State Air Pollution Control Board
629 East Main Street, P.O. Box 1105, Richmond, VA 23218.

Regarding: Comments concerning Operating Permit for the Mirant
Potomac River Generating Station.

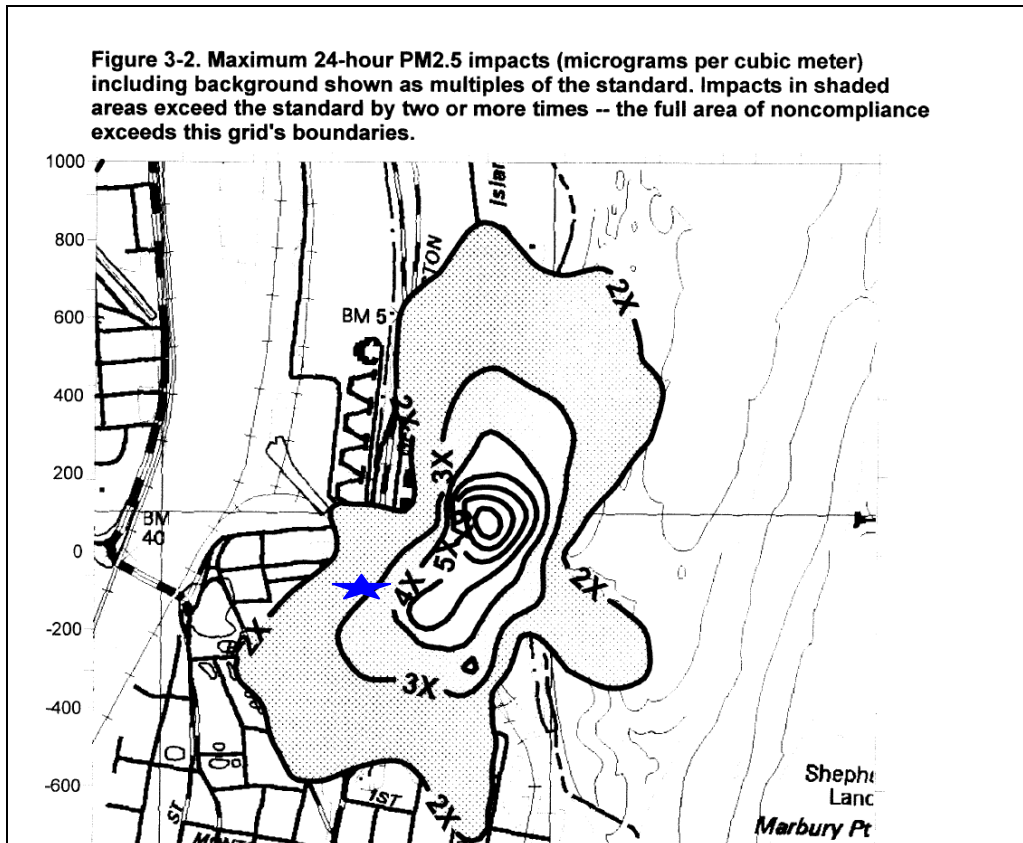
We live on 1217 Michigan Court, at the northeastern end of Alexandria, which is situated within ¼ mile of the plant, and according to both the Mirant and City of Alexandria studies, this area is impacted by the downwash effects of the Potomac River Generating Plant (see blue star in the Aero Engineering Report page 3-6). Although we show the Pm 2.5 effect, the report shows that both NOx and So2 exceedences affect us as well. We are, in effect, at Ground Zero for potentially harmful emissions. We would like to bring some of our concerns to your attention, they are as follows:

We live on 1217 Michigan Court situated within ¼ mile of the plant, and according to both the Mirant and City of Alexandria studies, we are impacted by the downwash effects of the Potomac River Generating Plant (see blue star in the Aero Engineering Report page 3-6).
